MAINE TURNPIKE AUTHORITY

ADDENDUM NO. 2

CONTRACT 2018.23

**MAINTENANCE GARAGE EXTENSIONS AND HVAC SYSTEM IMPROVEMENTS
IN AUBURN, CROSBY, GRAY, KENNEBUNK, AND LITCHFIELD**

253-SA-125

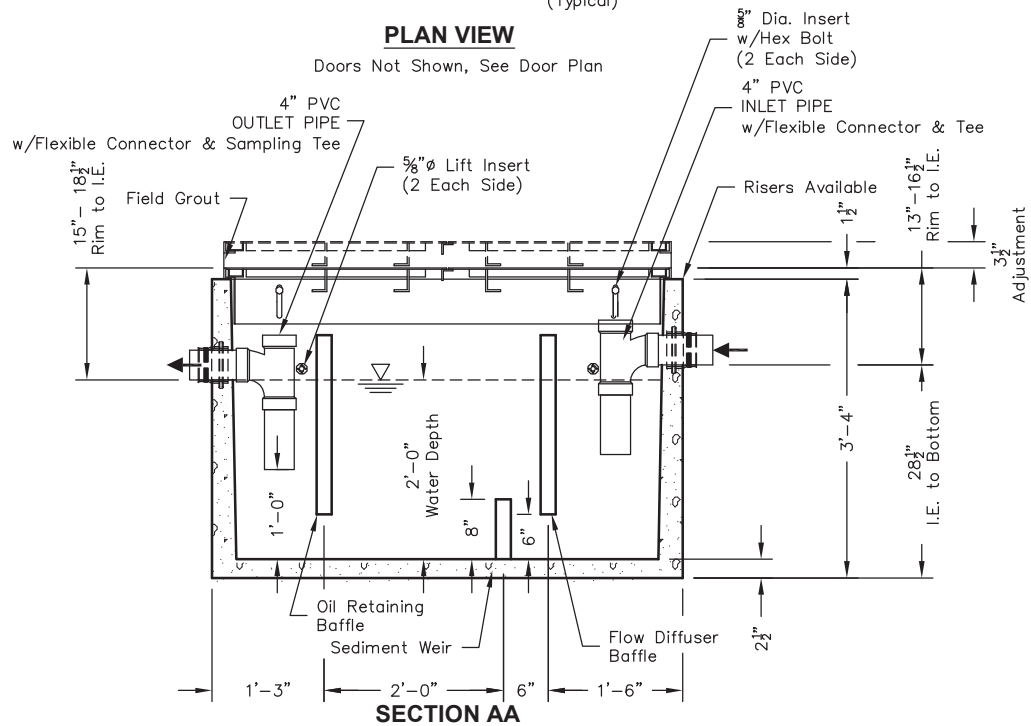
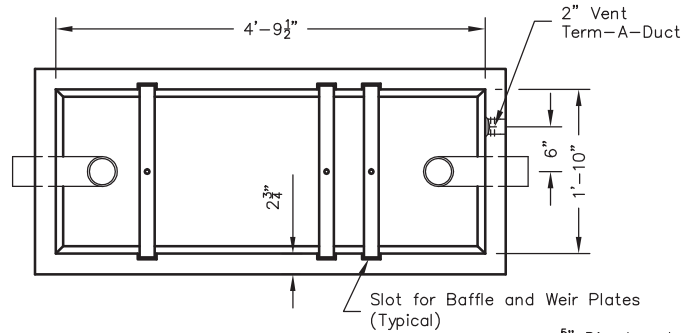
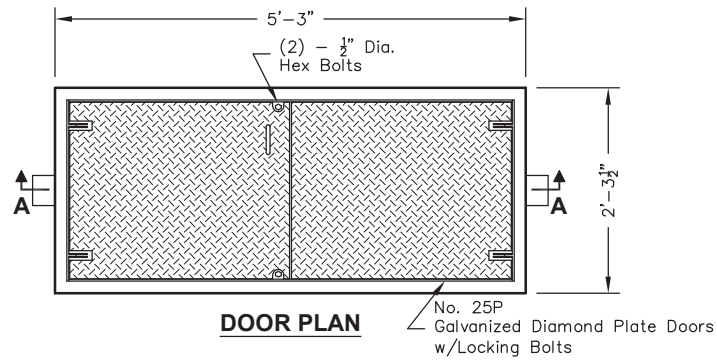
Question 22: In regards to the oil/water separator, there are no specifications listed on what is required for a tank. We will need specifications on the tanks for pricing.

Answer: See attached cutsheet, attachment 2.

SHEET NUMBER: E1

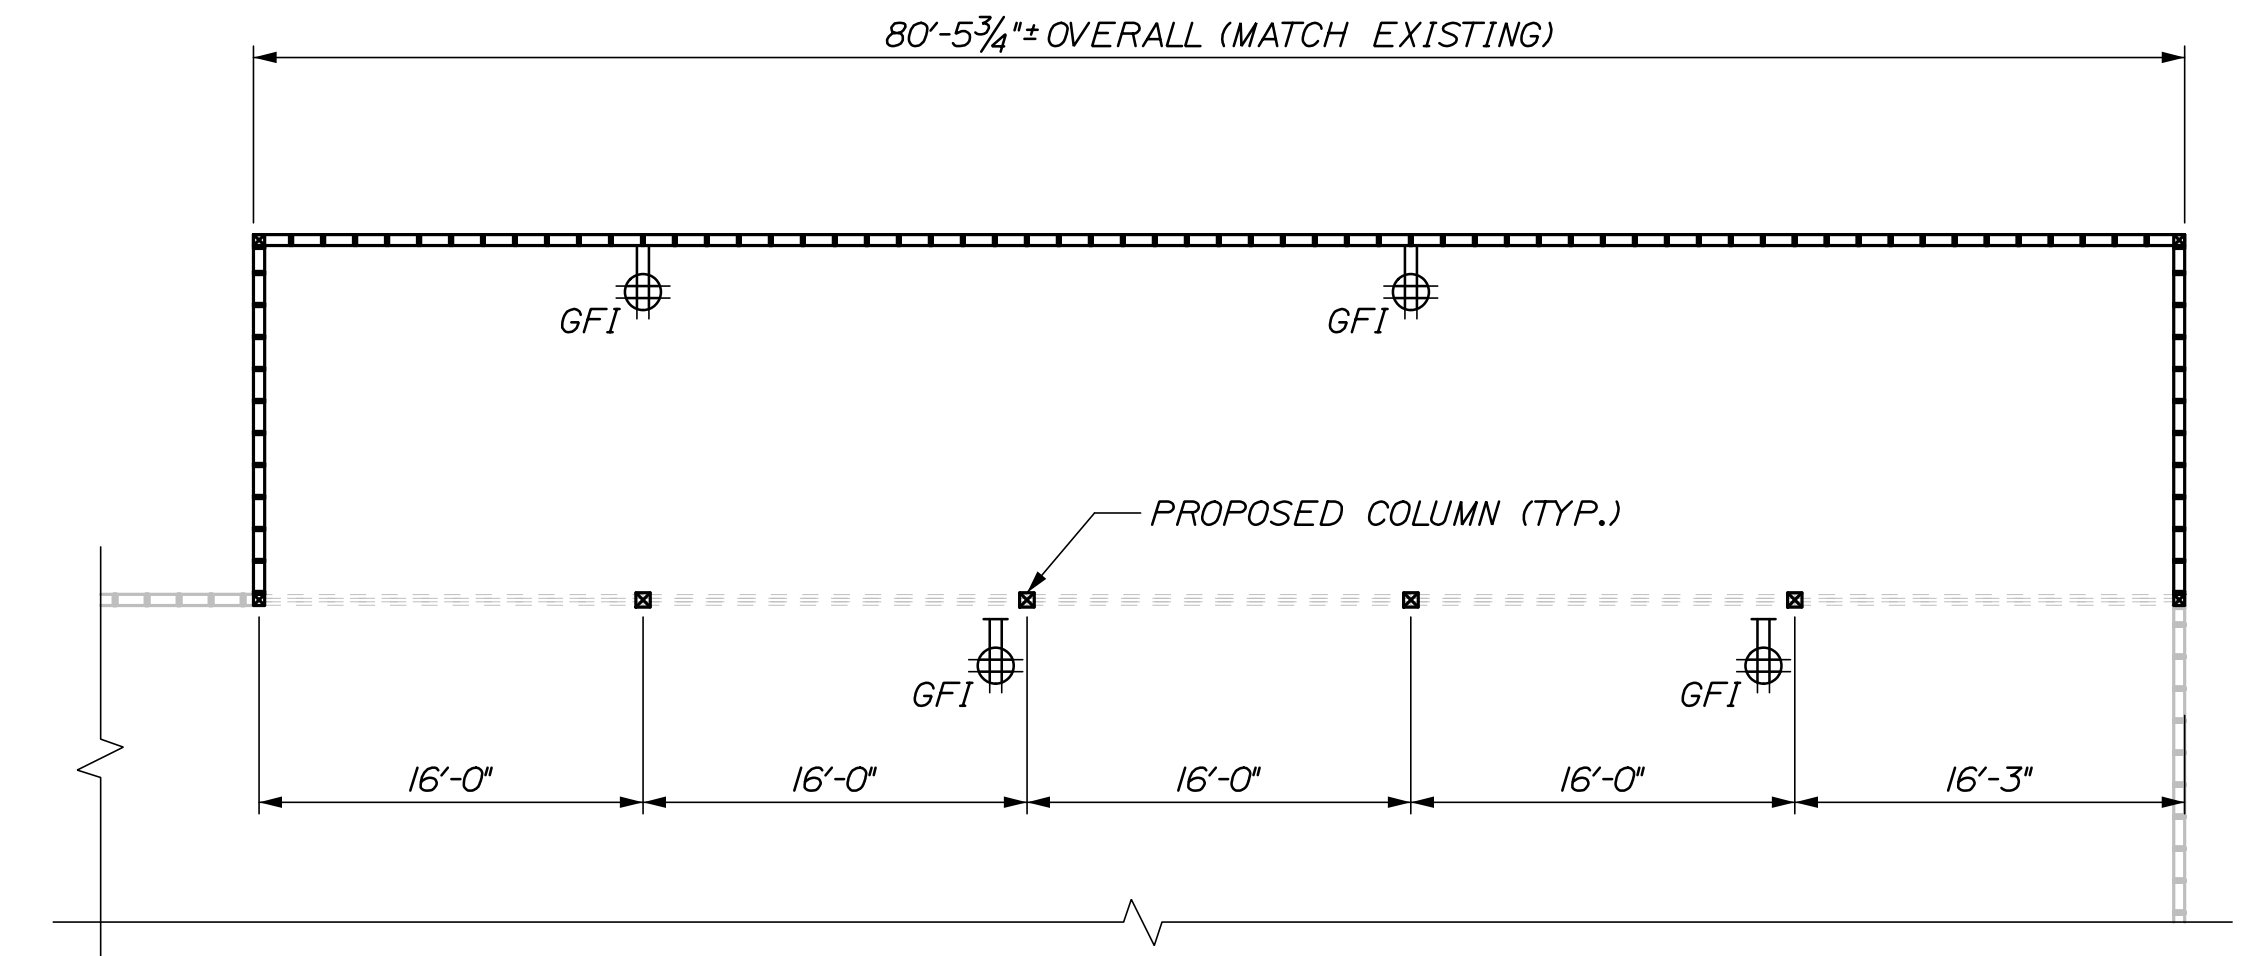
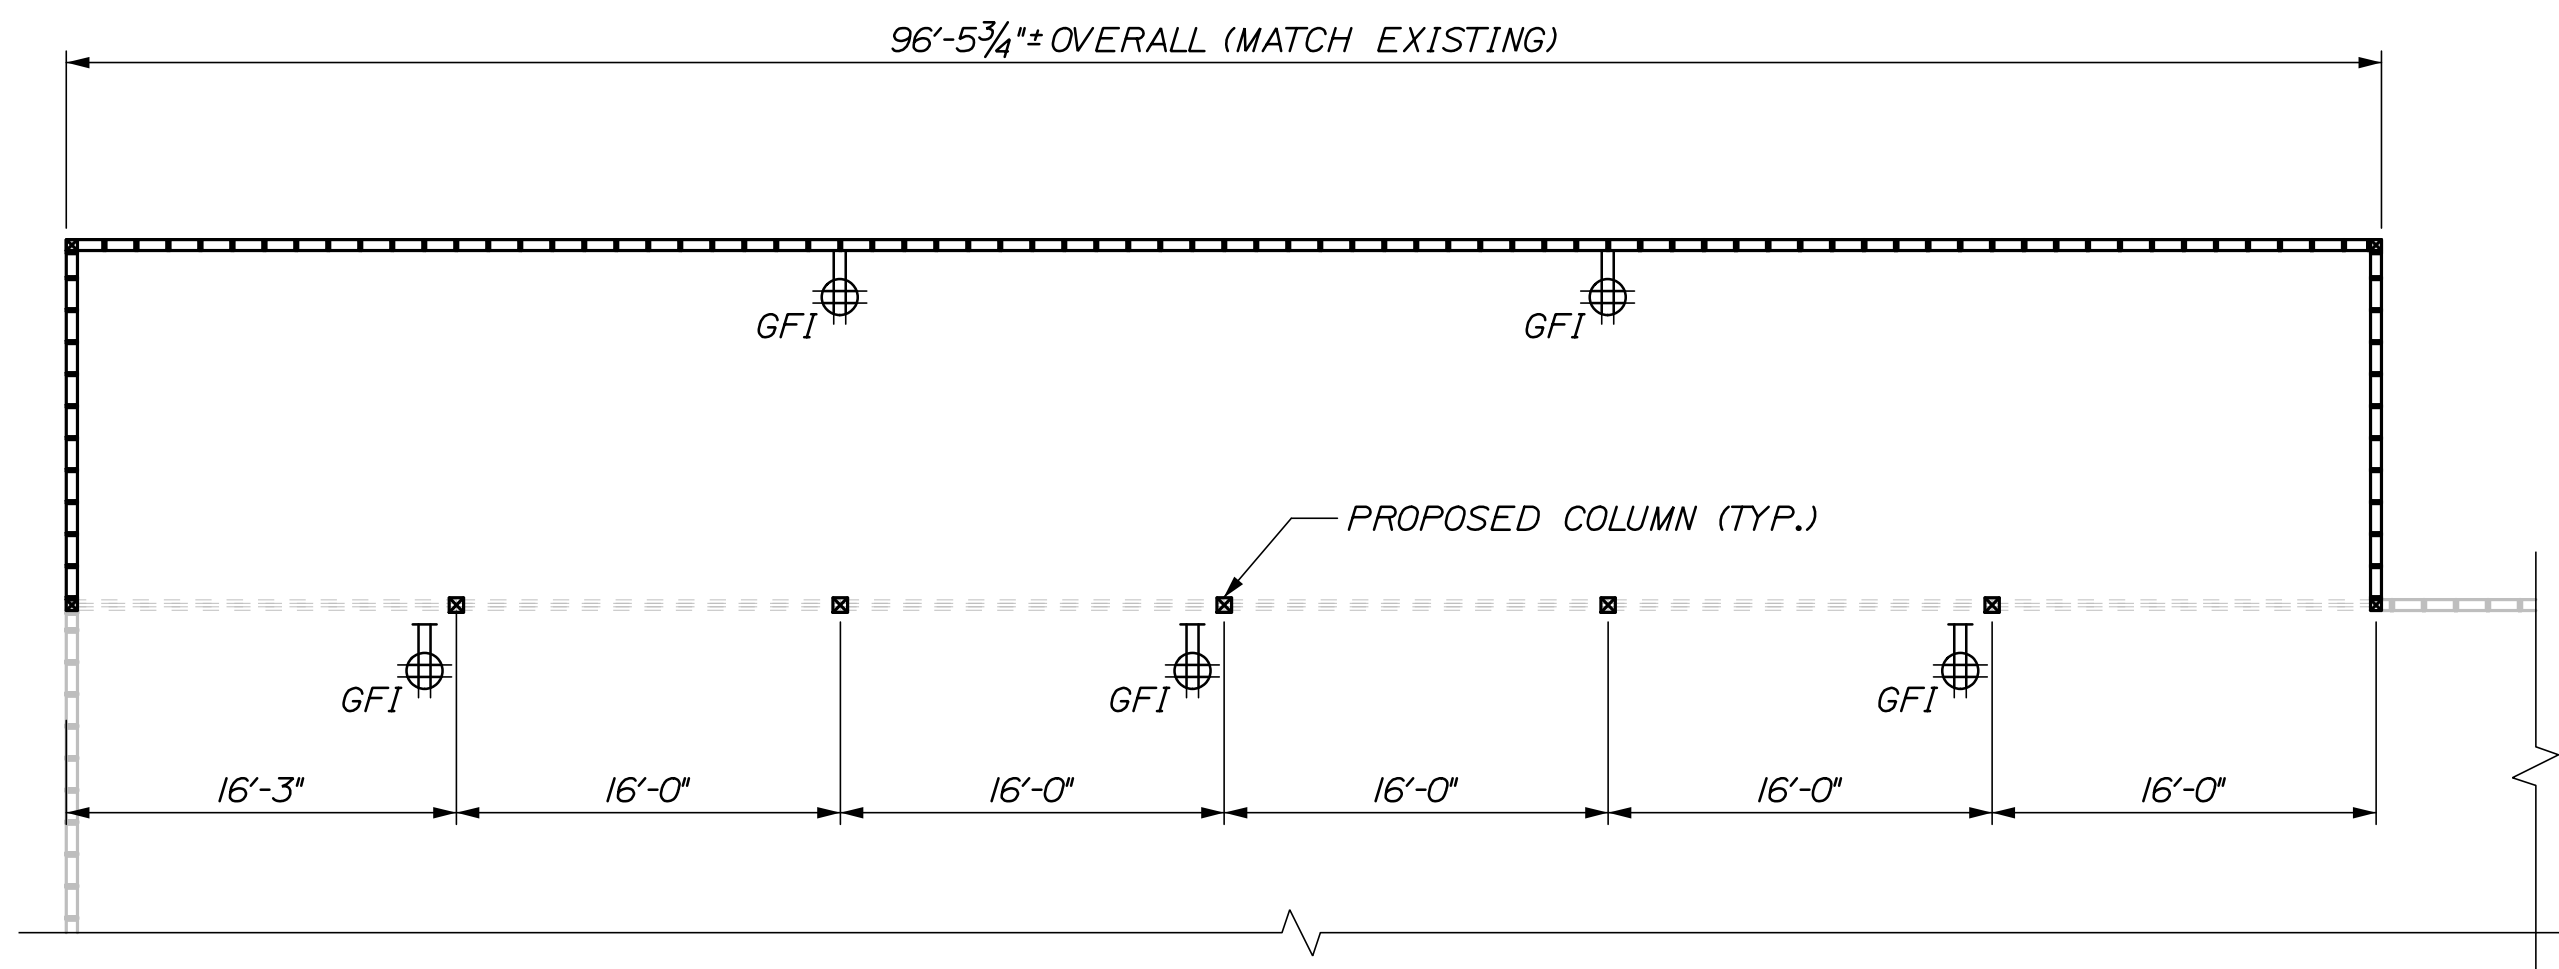
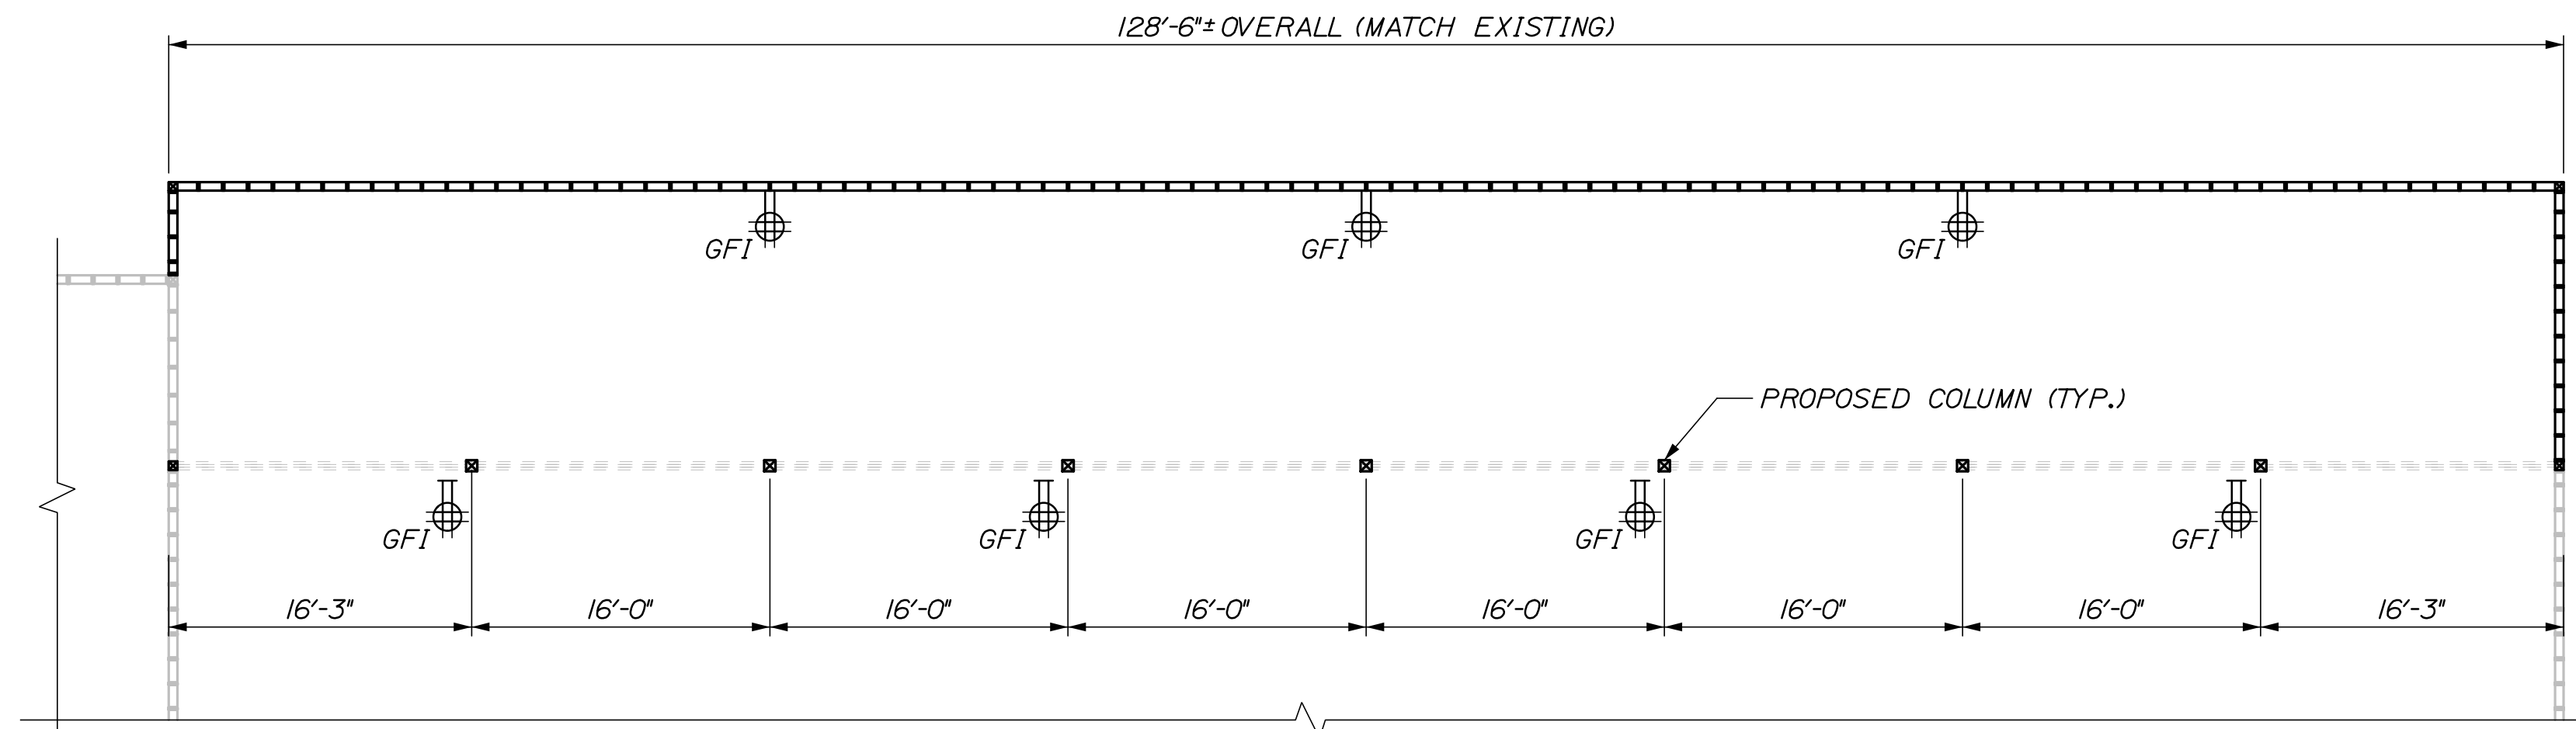
Question 7: 3 total exterior outlets? 1 quad and 2 duplex per building as noted on the power plans?

Answer: One exterior quad receptacle at each building as located by the Resident. 3 additional exterior duplex receptacles at all other buildings as located by the Resident, except Crosby #1 (5 bay), which will have 2 additional exterior duplex receptacles. One receptacle at each end wall of the buildings and 2 on the back wall of the buildings, except at Crosby #1 (5 bay), which will have 1 additional on the back wall. The Electrical Sheets E1 and E2 will be reissued with notes updated. The Quantity Sheet S2 will also be updated – see this addendum for updated plan sheets.

- ELECTRICAL NOTES:**
1. ALL PROPOSED CONDUIT IN EXTENDED SECTION OF GARAGE SHALL BE SURFACE MOUNTED AND MATCH EXISTING FEEDER CONDUIT.
 2. ALL RECEPTACLE BOXES SHALL BE SURFACE MOUNTED.
 3. ONE EXTERIOR MOUNTED QUAD RECEPTACLE SHALL BE MOUNTED ON THE OUTSIDE OF EACH OF THE MAINTENANCE GARAGES. THE RECEPTACLES WILL BE LOCATED BY A MTA MAINTENANCE REPRESENTATIVE.
 4. ALL NEEDED ELECTRICAL WORK SHALL BE INCIDENTAL TO THE LUMP SUM BUILDING ITEM.
 5. THREE (3) ADDITIONAL RECEPTACLES SHALL BE INSTALLED ON THE EXTERIOR OF EACH BUILDING EXCEPT CROSBY #1. TWO (2) ADDITIONAL RECEPTACLES SHALL BE INSTALLED ON THE EXTERIOR OF CROSBY BUILDING #1. RECEPTACLES WILL BE FIELD LOCATED BY THE RESIDENT.
